| REV | DATE     | DESCRIPTION        | DN | AP |
|-----|----------|--------------------|----|----|
| 8   | 12/11/25 | DA Response        | NC | MF |

SHEET TITLE  
BASEMENT 1 PLAN

PROJECT  
ORAN PARK  
COMMERCIAL 5  
PROJECT  
NO 12

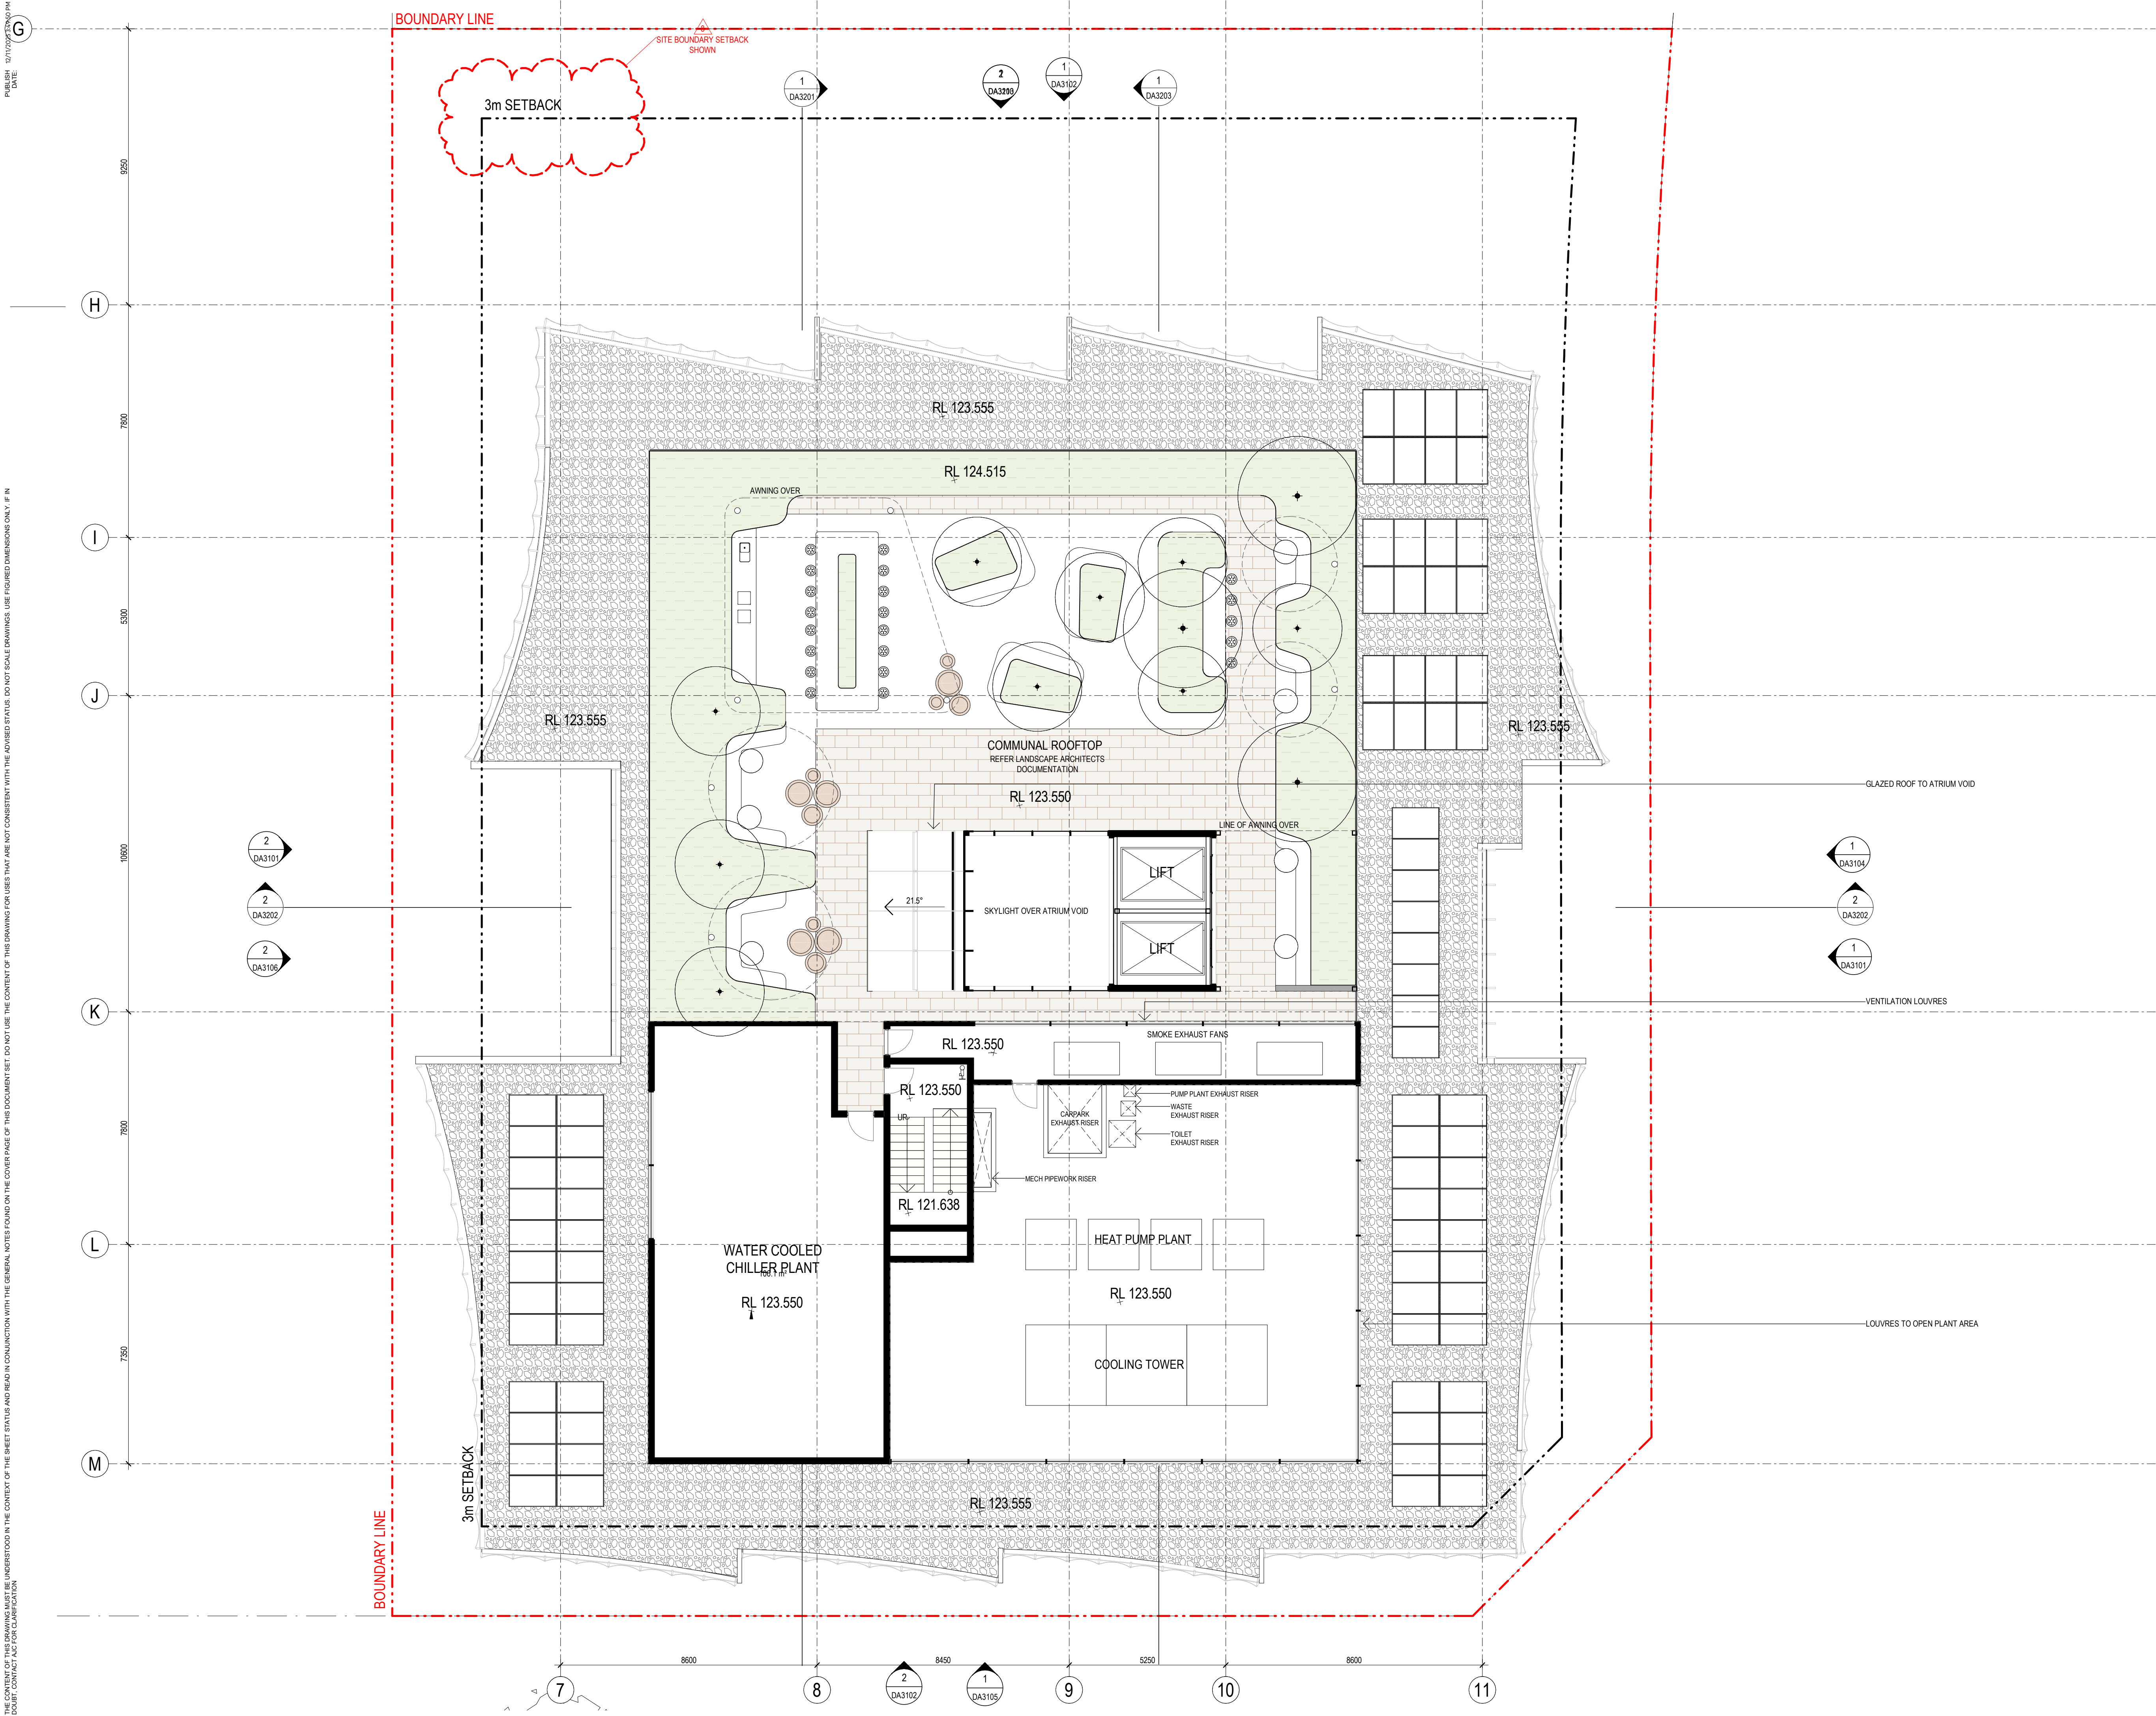
GENERAL NOTE:  
DIMENSIONS ADDED TO CAR PARK AREAS  
THROUGHOUT BASEMENT LEVELS

7  
ADDITIONAL DIMENSIONS  
ADDED

ADDITIONAL DIMENSIONS ADDED

GENERAL NOTE:  
DIMENSIONS ADDED TO CAR PARK AREAS  
THROUGHOUT BASEMENT LEVELS

NEW SHEET ADDED TO SHOW  
DETAILED CARPARKING SPACES  
UNDERNEATH RESI 4.

1  
CAR SPACE NUMBERS  
UPDATED AND ADDITIONAL  
VISITOR SPOT ADDED AND  
EV SPACES ADDED
